**SOLICITATION NUMBER: DEFK13002**  
**Addendum Number: 1**

Buckhannon AFRC - Buckhannon, WV

REF: **Buckhannon Readiness Center, Buckhannon, West Virginia**  
West Virginia Army National Guard  
RFQ No: DEFK 13002

SUBJ: **Addendum Bulletin No. 2**

**C1-3**

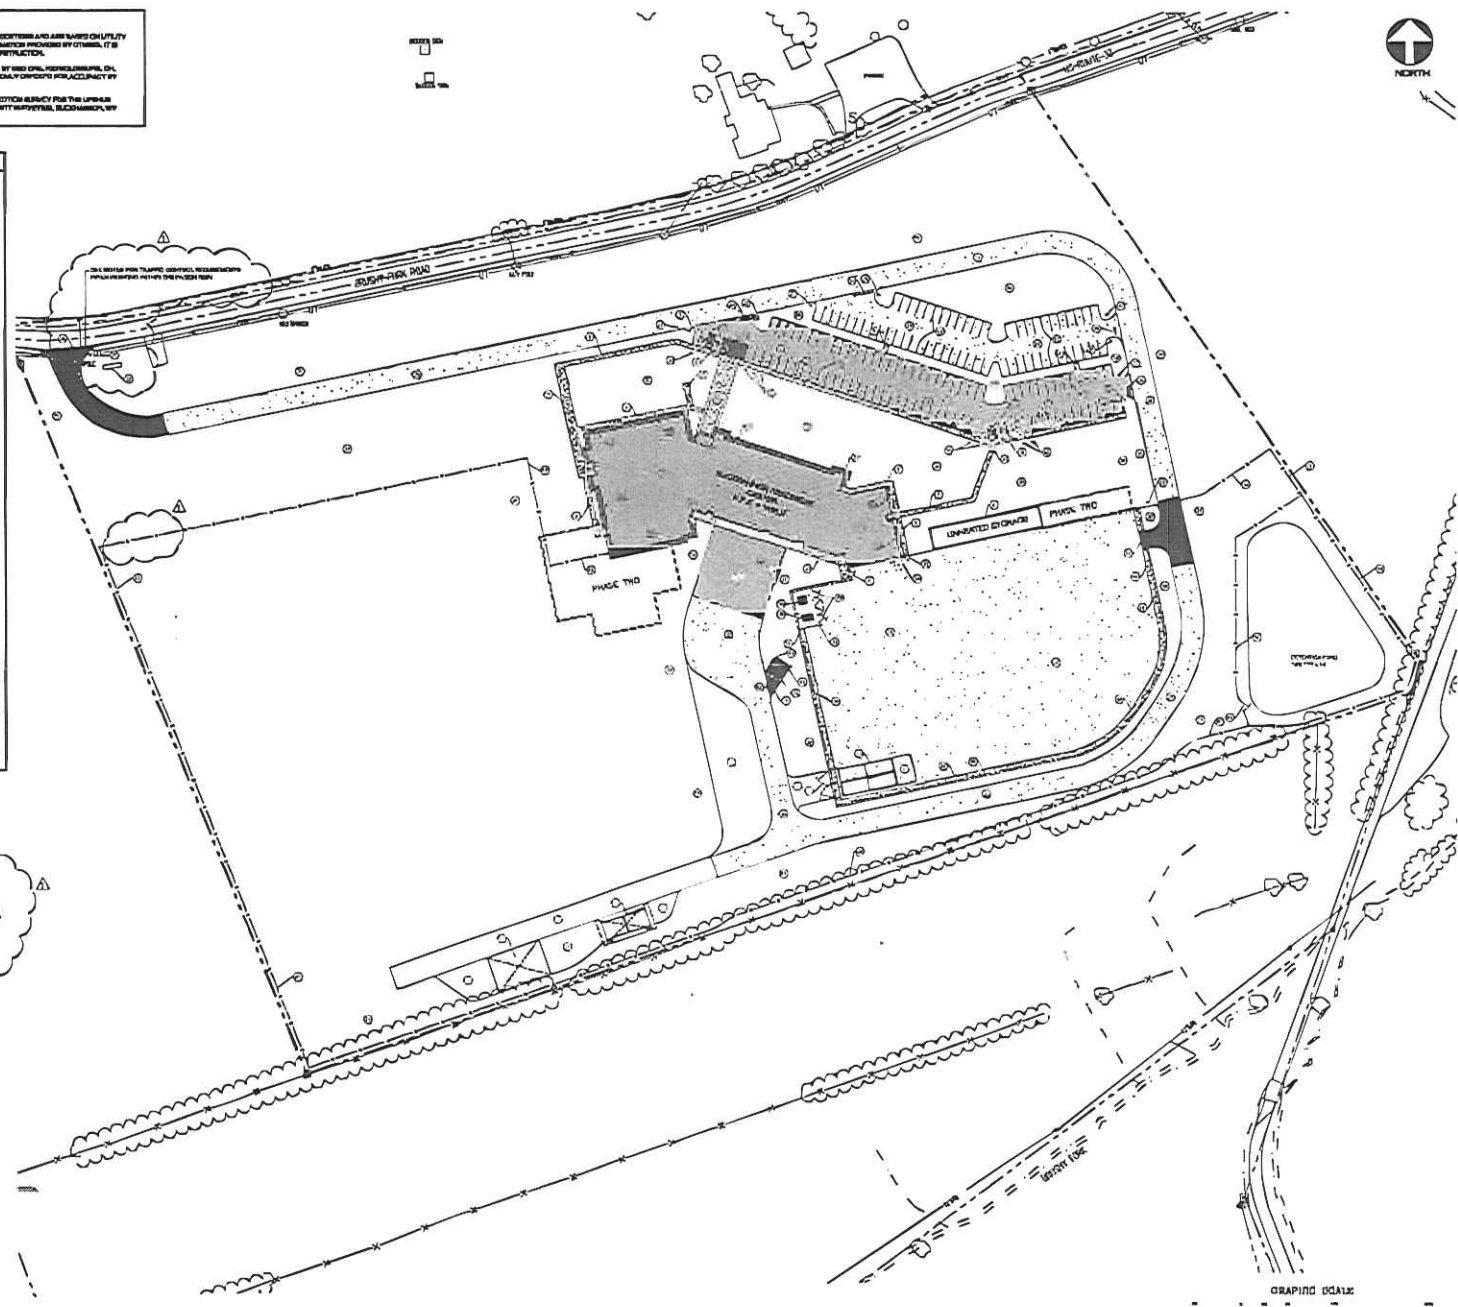
**Addendum 02 - Item 10, Drawing C-1.3:**

a. **REPLACE** Drawing C-1.3 dated 28 June 2012 with Drawing C-1.3, Revisions dated 5 September 2012. See Enclosures.

DATE: 11/10/2011  
TIME: 10:11:11 AM  
PROJECT: C2-12

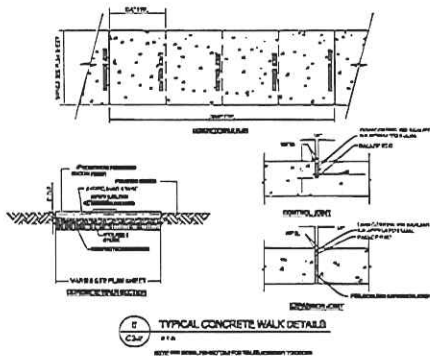
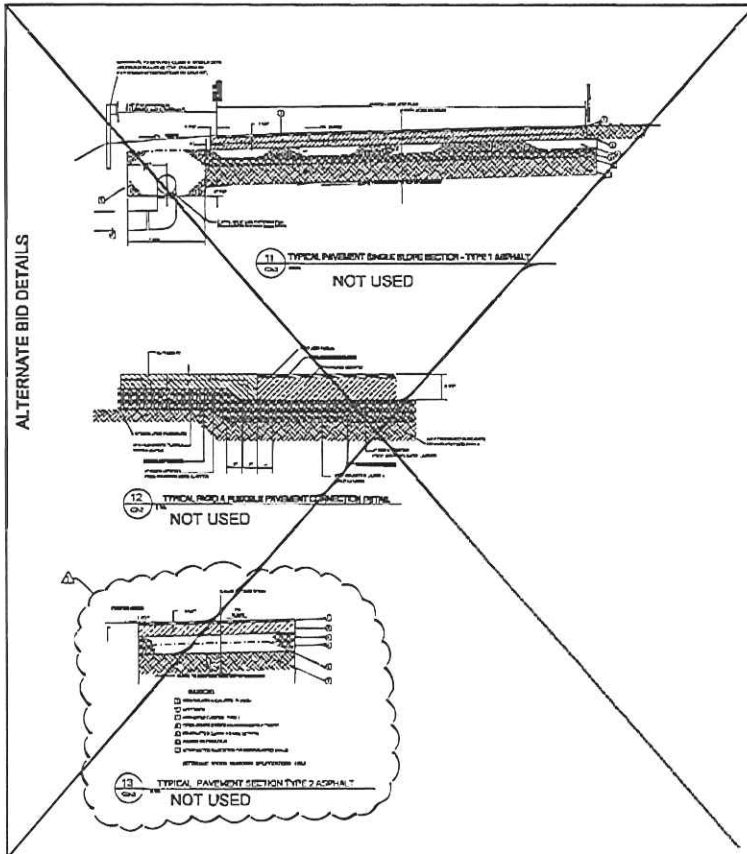
**Addendum 02 - Item 12, Drawing C-2.12:**

- a. **REPLACE** Drawing C-2.12 dated 28 June 2012 with Drawing C-2.12, Revisions dated 5 September 2012. See Enclosures.

FRONT ELEVATION - REFERENCE

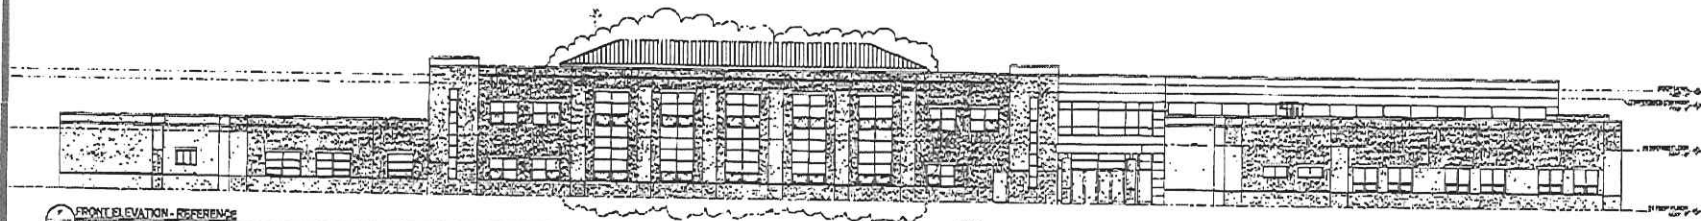
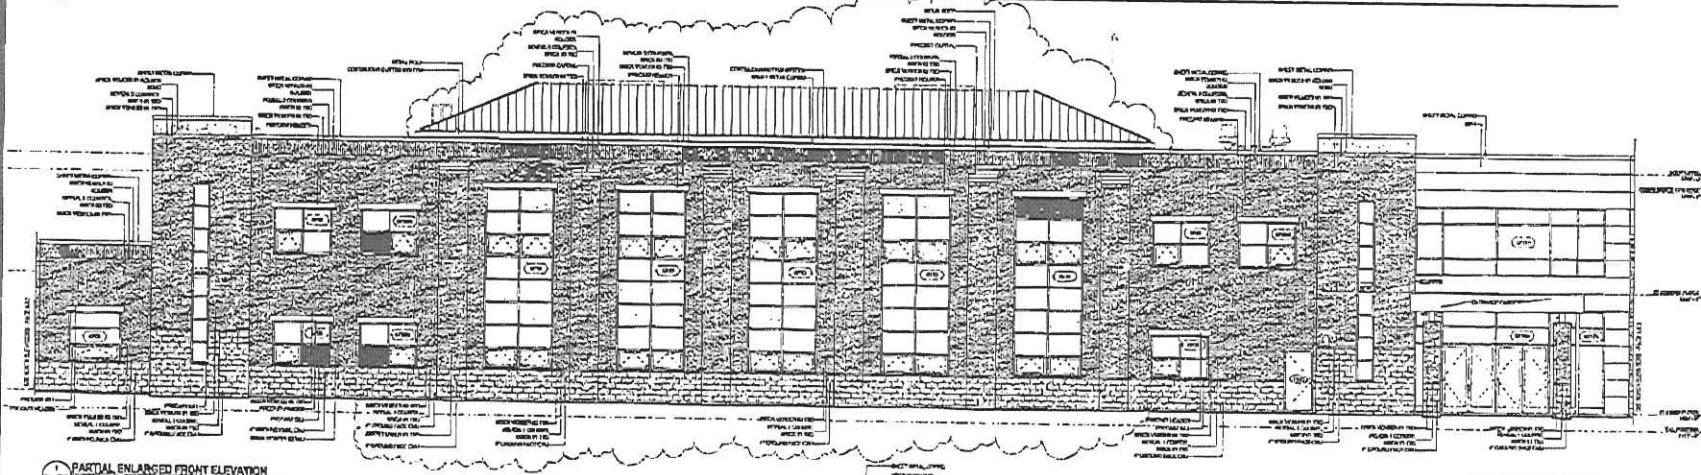
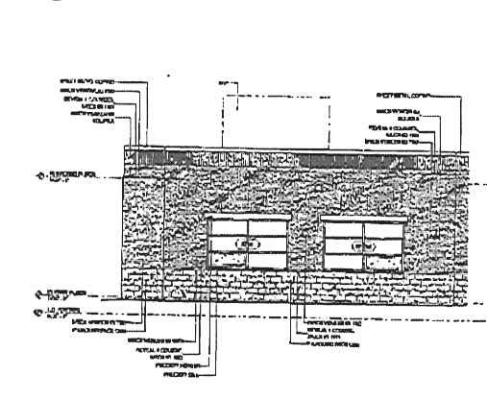
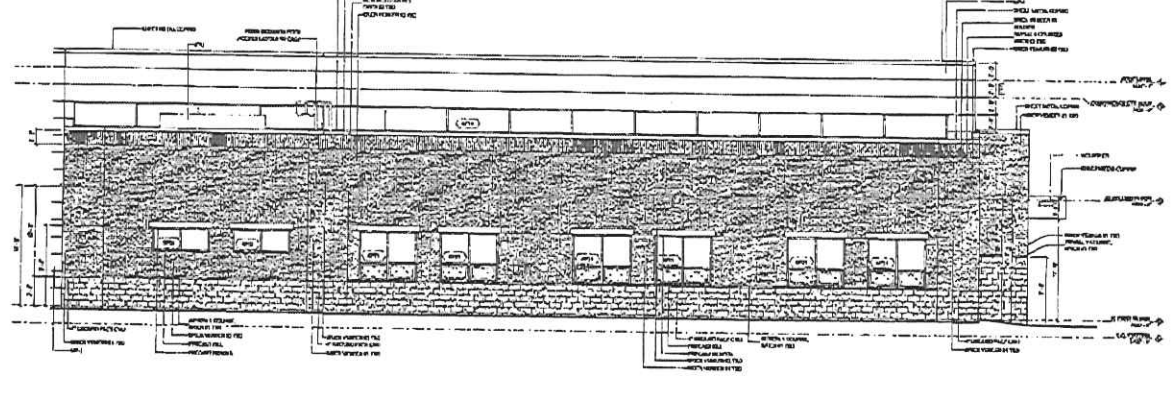
**Addendum 02 - Item 18. Drawing A-2.1:**

- a. **DELETE** Pre-Cast Entablature on front elevation along with the structural steel. See Enclosure A-2.1
- b. **REPLACE** Ground Face CMU at the base of wall for the entire building perimeter with Matte Face CMU.
- c. **DELETE** Pre-Cast Banding where indicated on Drawing A-2.1. See Enclosure A-2.1

SHEET NO.  
**SKA007**

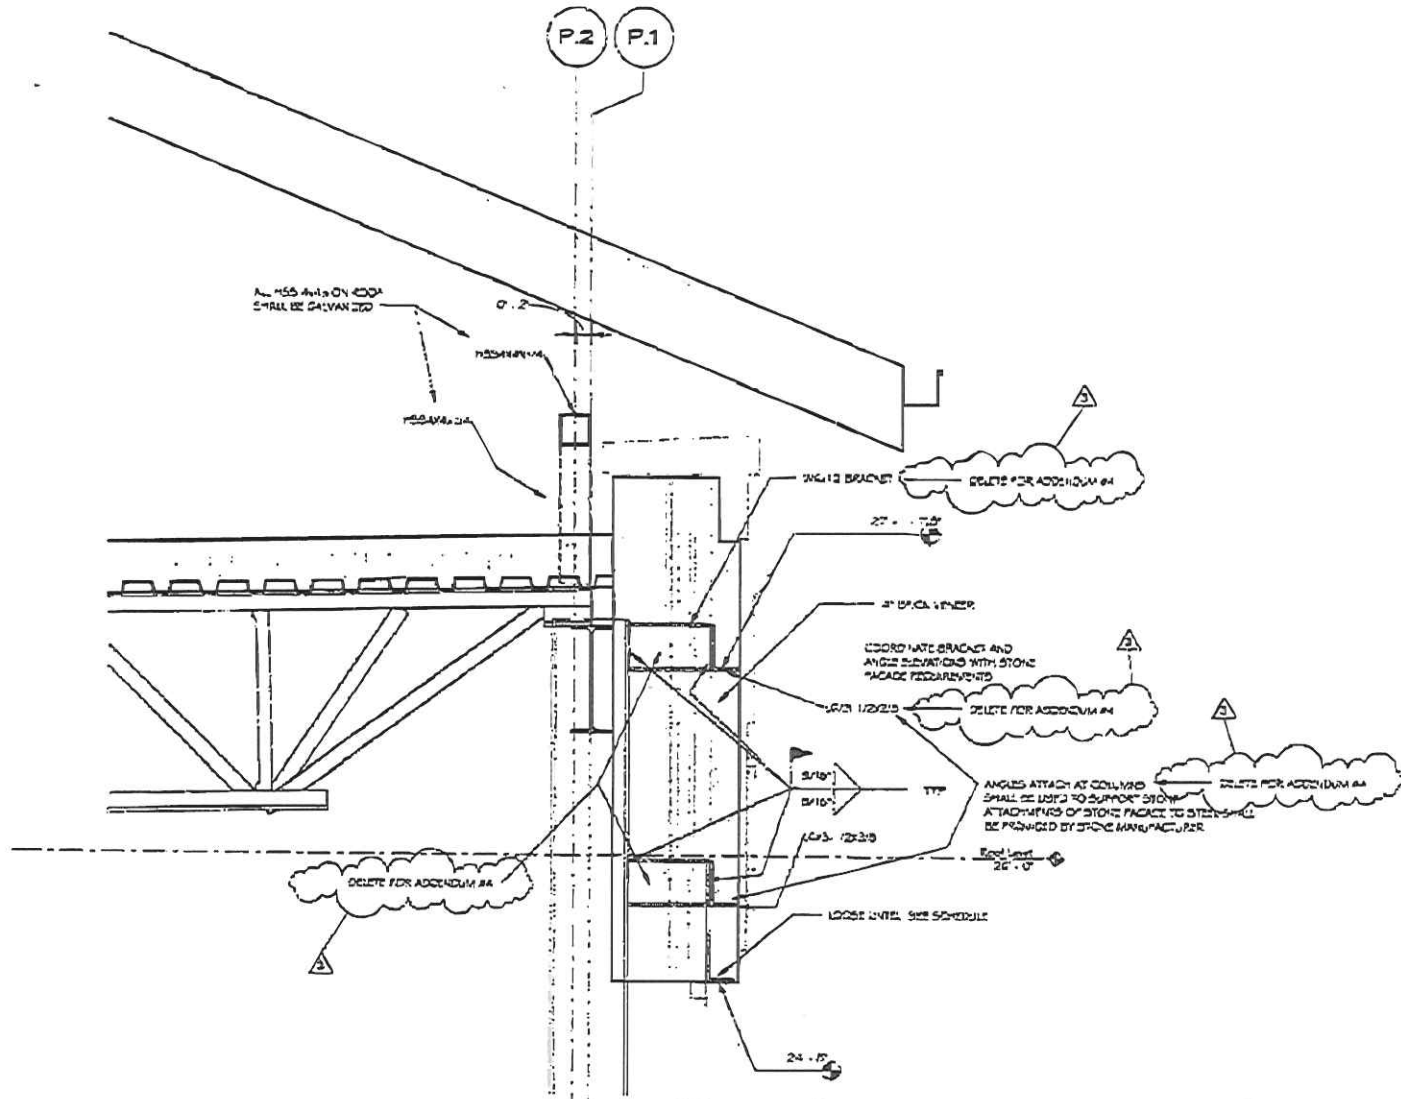
- a. **DELETE** Wood Veneered Accent wall at the Recruiting Office Room 101 and replace necessary portions of wall behind with Drywall.
- b. **DELETE** Terrazzo Tile and wall base in Lobby Rooms 100, 100A, 100B & 100D as Base Bid item. Terrazzo Tile and wall base will be Alternate Bid Item # 10.

- c. **ADD VET** (Vinyl Enhanced Tile) and Molded Rubber wall base in Lobby Rooms 100, 100A, 100B & 100D as Base Bid. See SKA-007 Room Finish Schedule in Enclosures.
